Evaluation of Seismic Conditions Near the Site

SUBJECT: TRANSMITTAL OF NRC'S RESPONSE TO EVALUATION OF SEISMIC
CONDITIONS NEAR YOUR SITE

**SUBJECT: SEQUOYAH FUELS CORPORATION (SFC) SITE EVALUATION OF FAULTS
AND FAULTING: INPUT TO SAFETY EVALUATION REPORT**

SEQUOYAH FUELS CORPORATION	
Site Characterization Report	
Geological Cross Section A-A'-A'	
93092M18	RSA
REV. 0	
DATE 12/18/95	FIGURE NO. 11

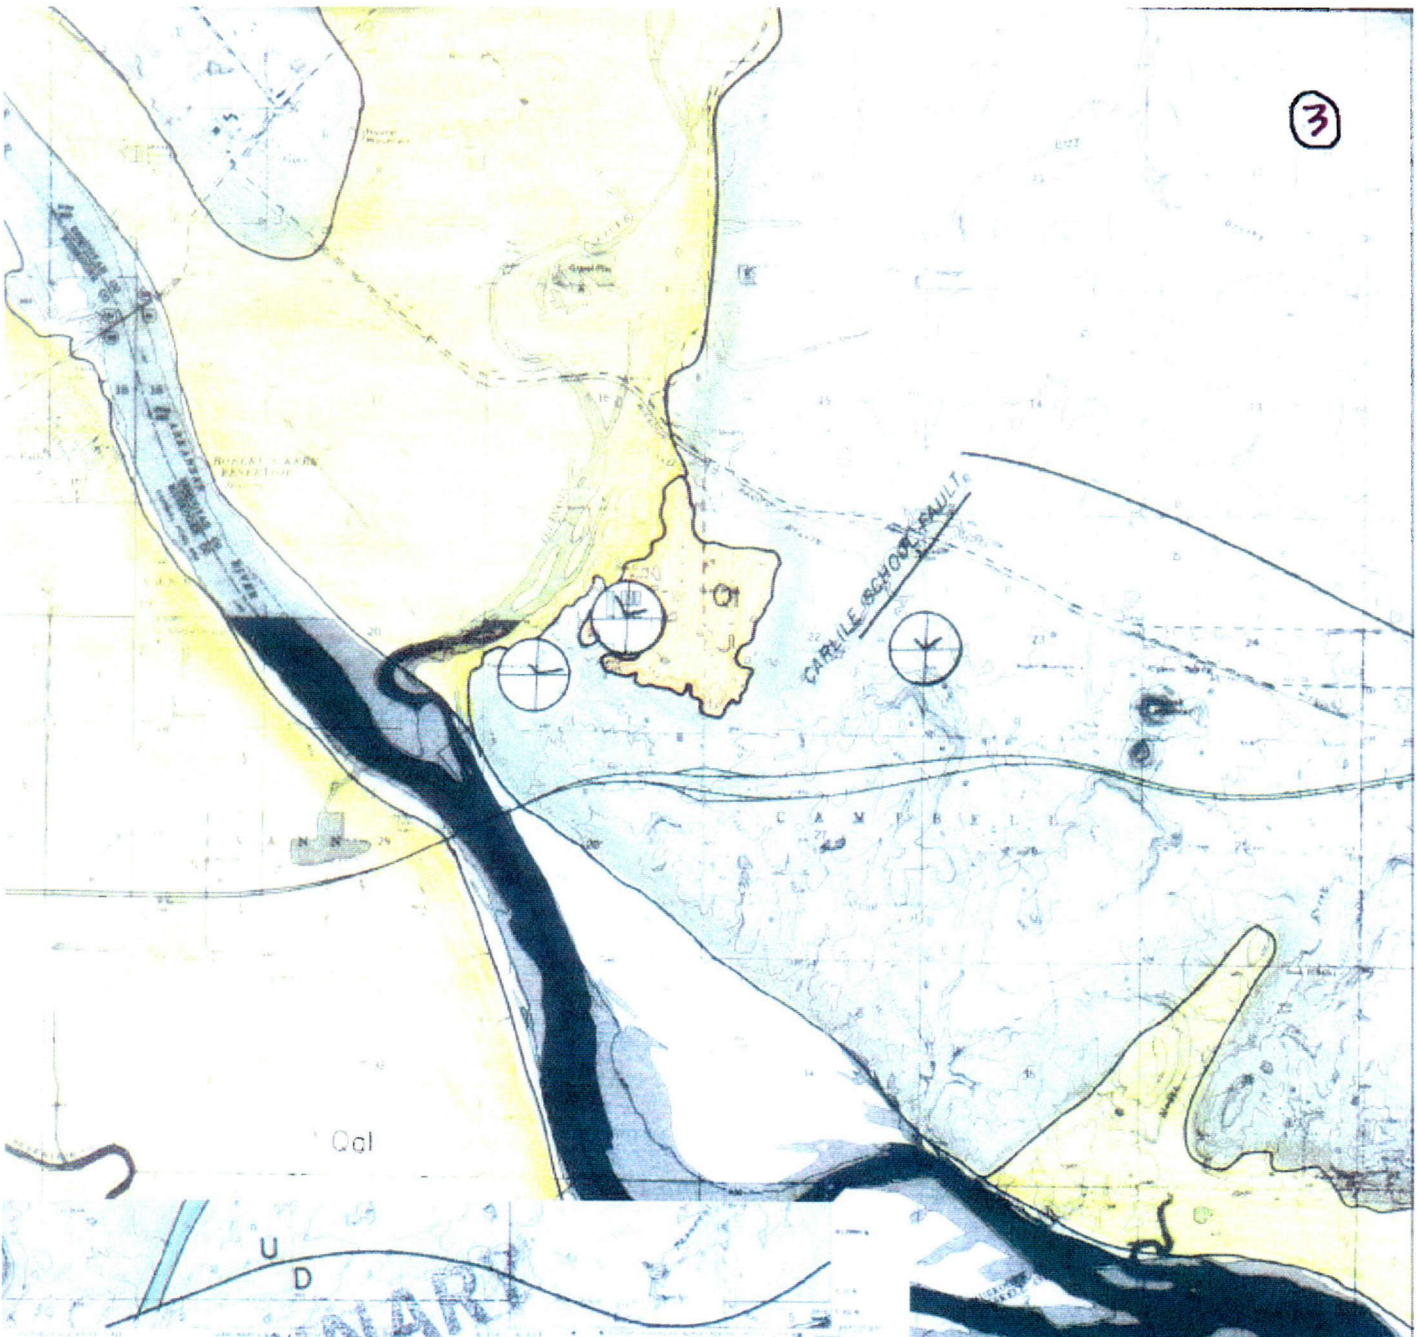
The Carlile Fault, the closest fault to the site, is shown to intersect the Marble City Fault (MCF) on one map, but not on another. Both maps were submitted by SFC. Also, a cross section showed that parts of the South Fault of Warner Uplift (SFU) and the Carlile fault (CF) were a few thousand feet deep and did not penetrate the granite basement rocks (SCR, Figure 11, attachment 2). The fault lengths, fault-zone widths, depth, and connectivity of the faults on the SFC maps and cross sections are not well constrained, and vary from map to map. This is due to a dearth of data that may only be derived from better exposures, borehole penetrations and geophysical surveys. These and other discrepancies have been satisfactorily explained in the April 8, 1998, letter.

SFC's explanation for the E-W splay of the CF that appears in attachment 1 (dashed line) is reasonable and acceptable (April 8, 1998 letter). Thus, the E-W splay, the only fault that has been suggested to occur within the site boundary, has little or no basis in fact, and need not be considered in establishing the seismic design basis.

GEOLOGIC MAP

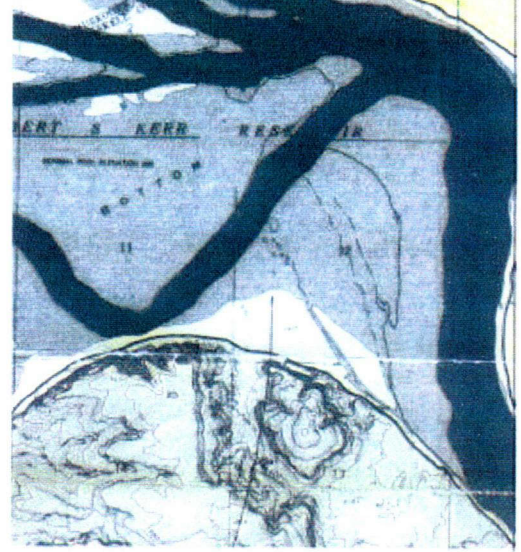
I. Marble City Fault (MCF). The trace of the MCF near the SFC site has not been located consistently by SFC (e.g., Chenoweth, 1983; SCR, 1996; Van Arsdale, 1998). For example, the location of the MCF with regard to the Carlile Fault (CF) is near the northern terminus of the CF and the MCF does not intersect the CF at the surface (Chenoweth, Attachment 3; and Van

Arsdale, Attachment 4 show the CF to be 1 mile long), whereas the location of the MCF is near the southern terminus of the CF in the SCR (the CF is shown to be 4 mi long; Attachment 1).
